LINOTYPE IMPROVEMENT SHEET

NO. 293

JUSTIFICATION RELEASE CAM LEVER SPRING

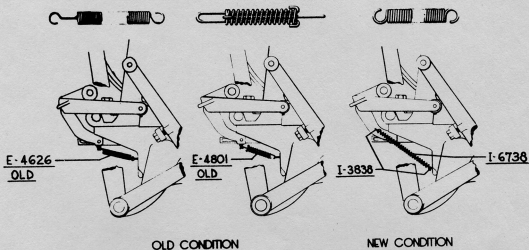
This improvement provides a Spring that will stand up under all working conditions.

Can be applied to all 30 Em Machines equipped with Self Quadder by substituting I-6738 and (2) Hooks I-3838.
